Access Compliance Report

Public Rights-of-Way

(Pedestrian Signals)

Intersection ID: N/A	Main Street:	Cross Street: N/A	Location: N/A
ADA ID: 2B10E7C477A7	Signal Type: One Push Button-Non APS	Overall Compliance: No	Severity Score: BTN 1: N/A BTN 2: N/A No BTN: N/A
Codes/Mitigation Info/Possible Solution		Field Measurements/Component Compliance

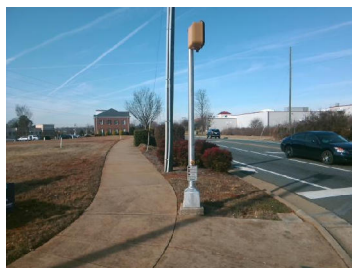
PROW/ADA: TMUTCD 4e.08, R404.2, R404.3

Possible Solutions: Replace Signal Push Button With APS Button on New Post. Remove & Relocate Sign.
